SUBJECT: SUMMARY OF MAY 12, 1988 MEETING WITH TU ELECTRIC

At a meeting held on May 12, 1988 in Rockville, Maryland, NRC staff met with TU Electric to discuss a design change involving the backup meteorological monitoring tower at Comanche Peak Steam Electric Station. A list of attendees is provided as Enclosure 1. TU Electric is seeking the staff's approval for relocation of the backup met tower in order to resolve certain emergency planning open issues (Enclosure 2 contains the slides presented at the meeting). Open issues 445/8807-02 and 446/8806-02 concern data recovery in that the applicant has not been able to demonstrate long-term joint data recovery greater than 90%. Open issues 445/8333-70 and 445/8317-70 concern representativeness in that the applicant has not been successful in conducting a real-time comparison of 10-meter data from the backup tower with similar data from the primary tower. Relocation of the backup tower from its current location 3/4 mile west of the primary tower to the proposed location about 75 feet east of the primary tower would facilitate calibration, repairs and maintenance and would serve to enhance reliability and data recovery. The proposed rel

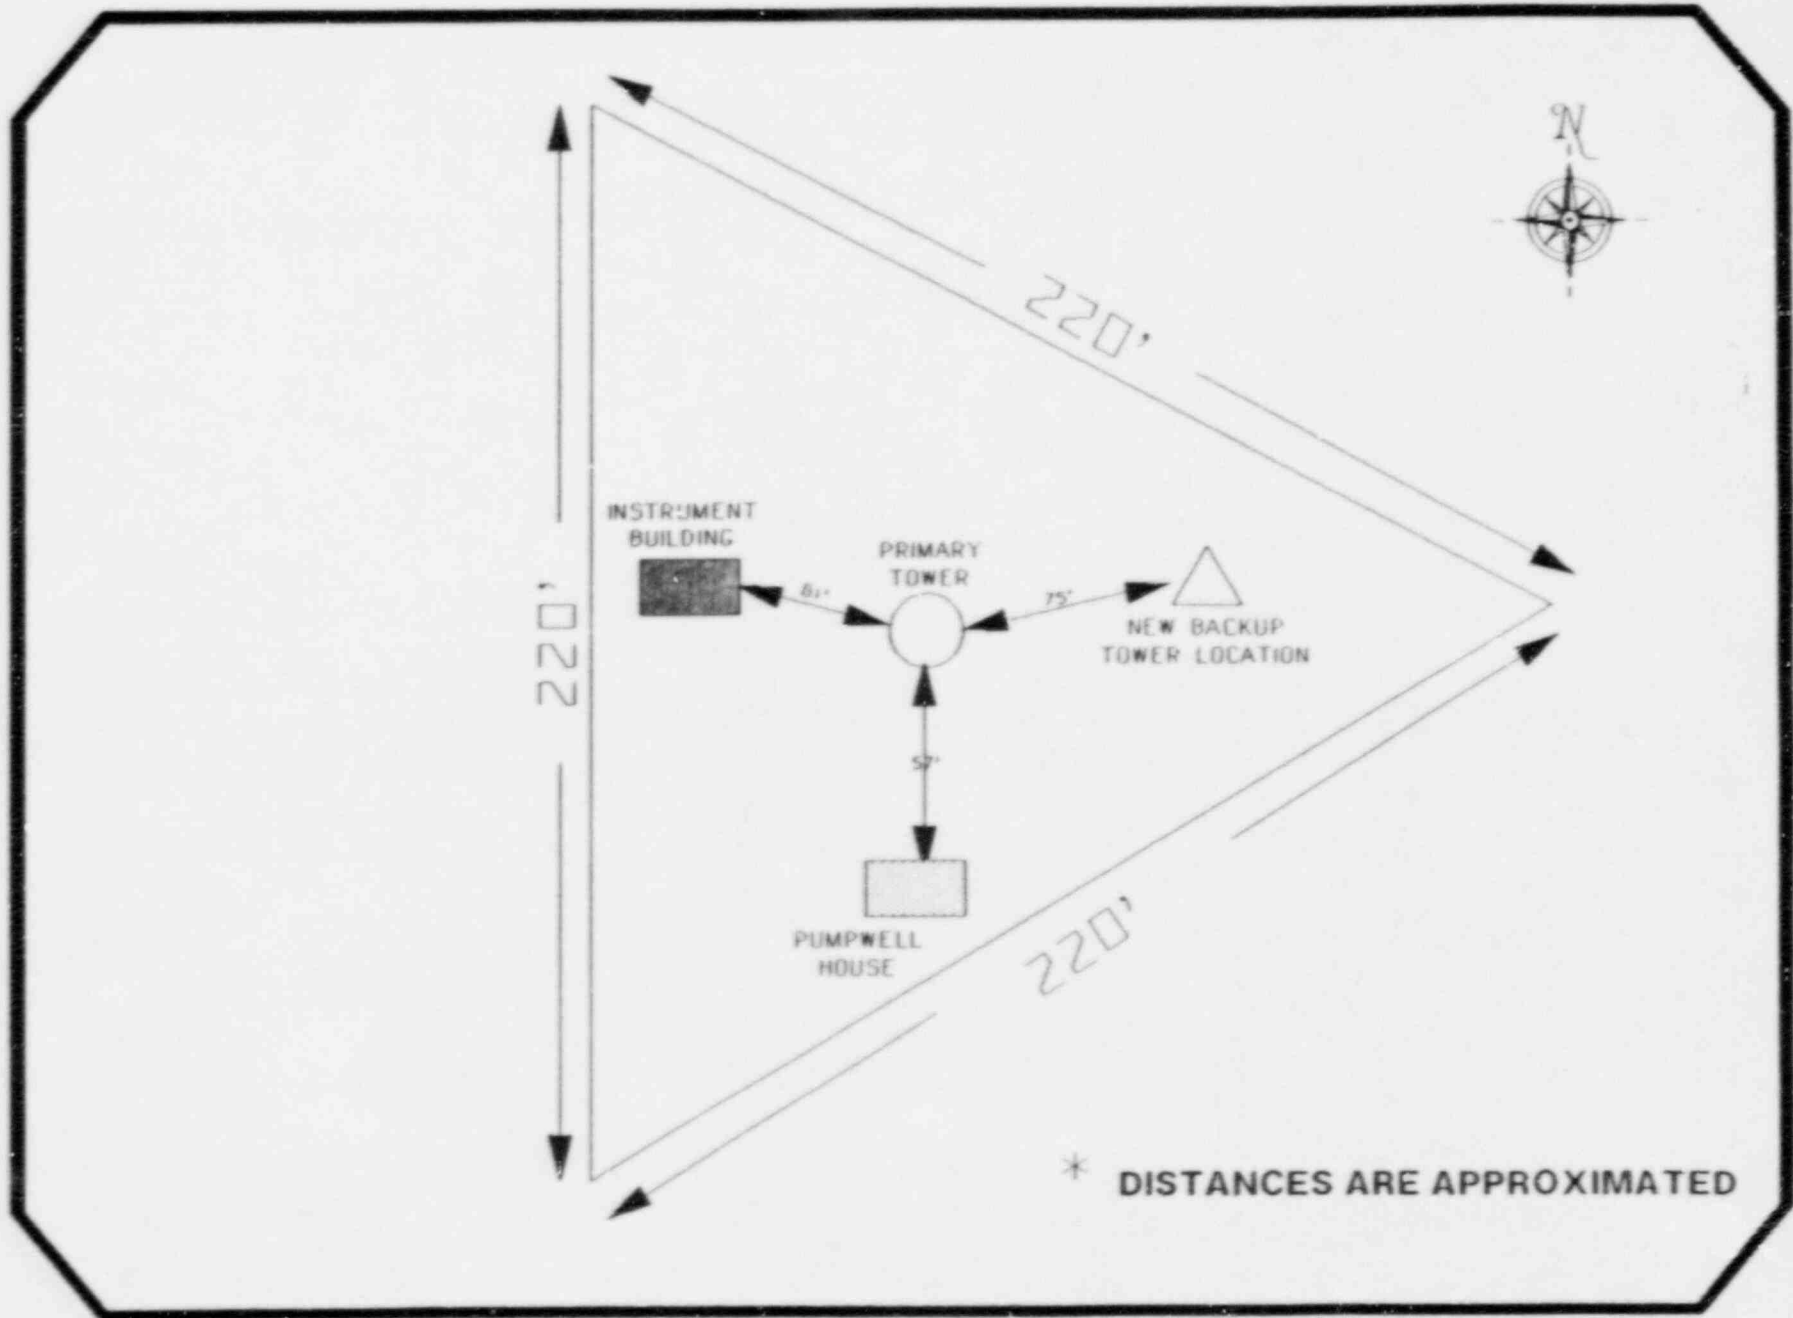
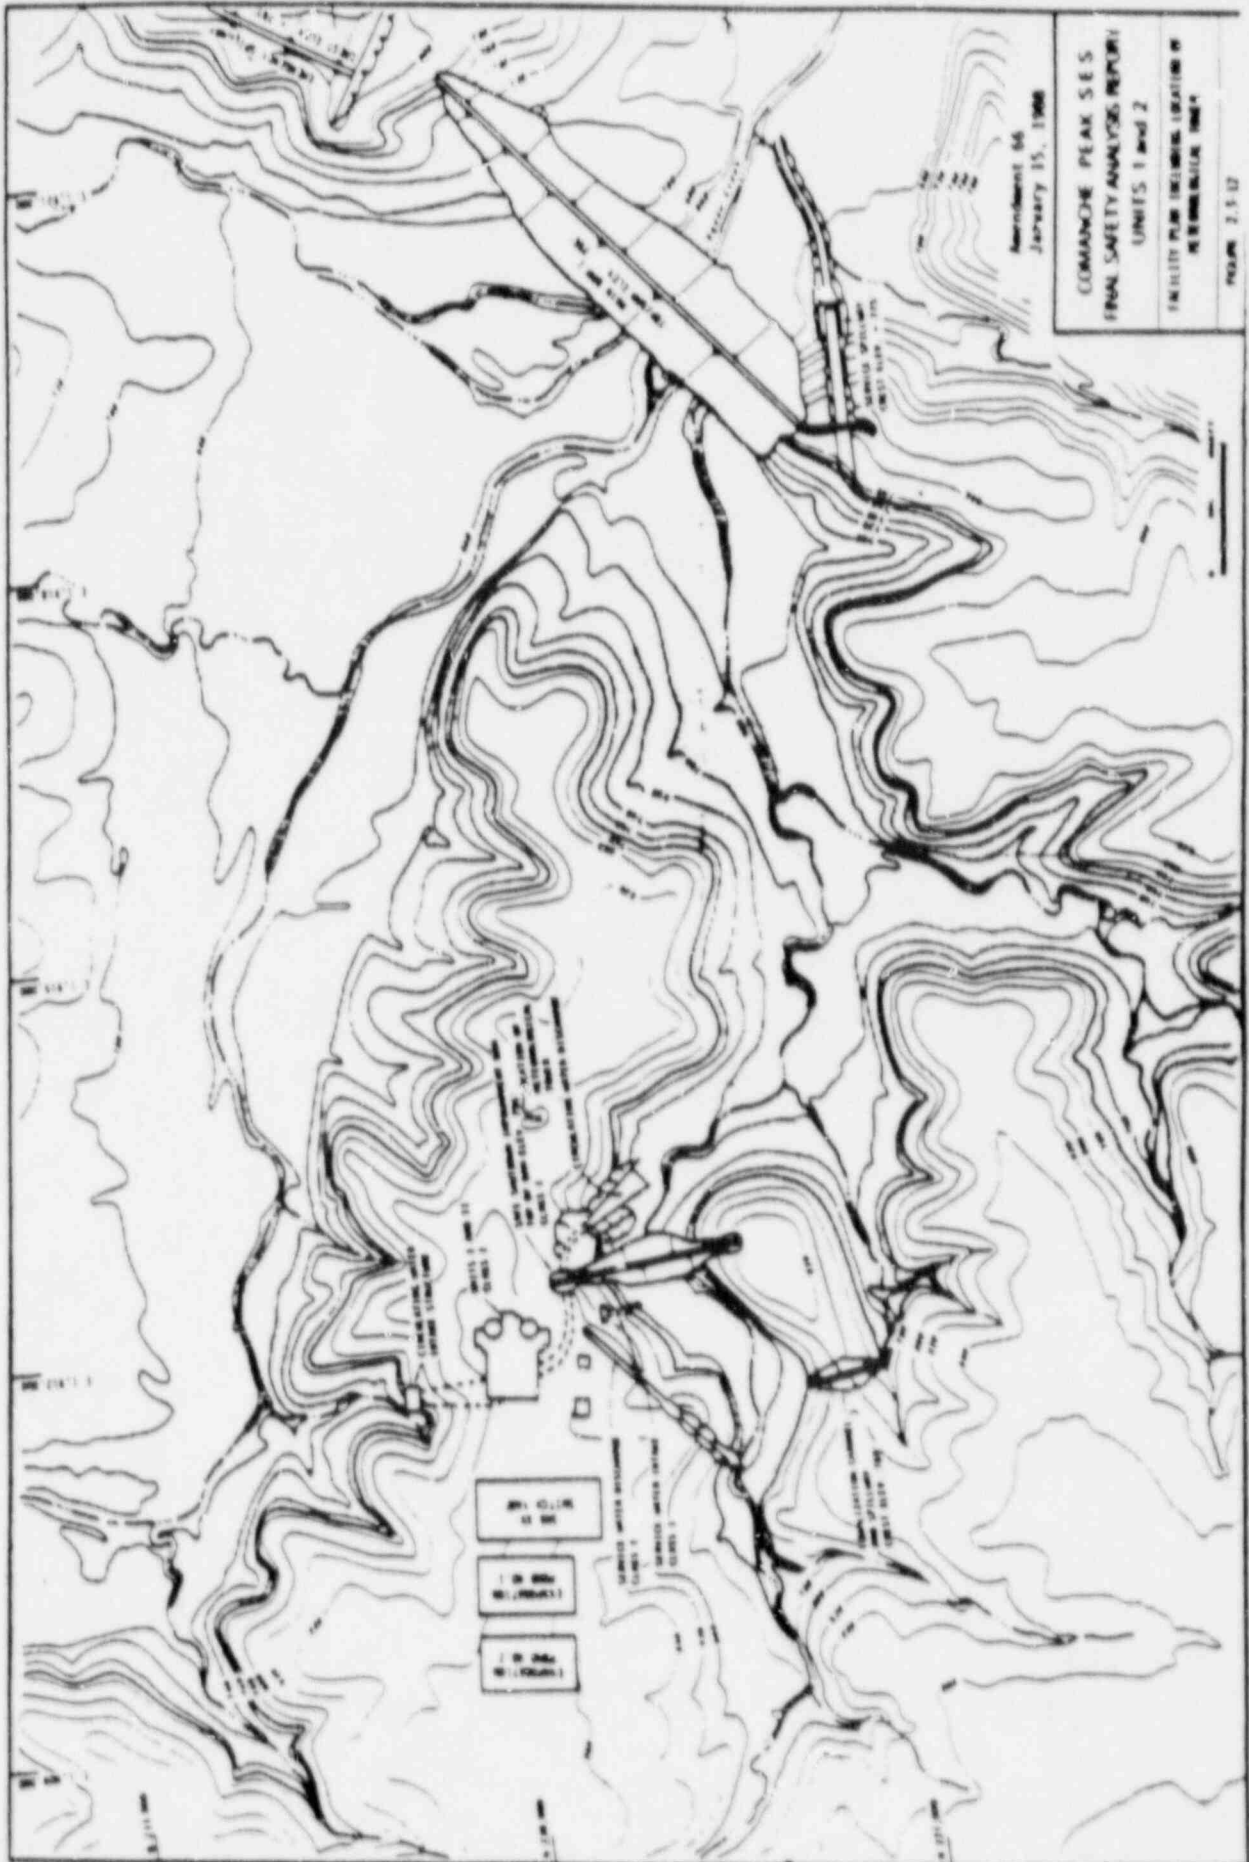
**PROVIDE A REAL-TIME COMPARISON OF
10 METER DATA FROM THE BACK UP TOWER
WITH SIMILIAR DATA FROM THE PRIMARY TOWER**

**RELOCATION OF BACK UP TOWER NEAR
THE PRIMARY TOWER WILL PROVIDE DATA
WHICH ADDRESSES THIS CONCERN**
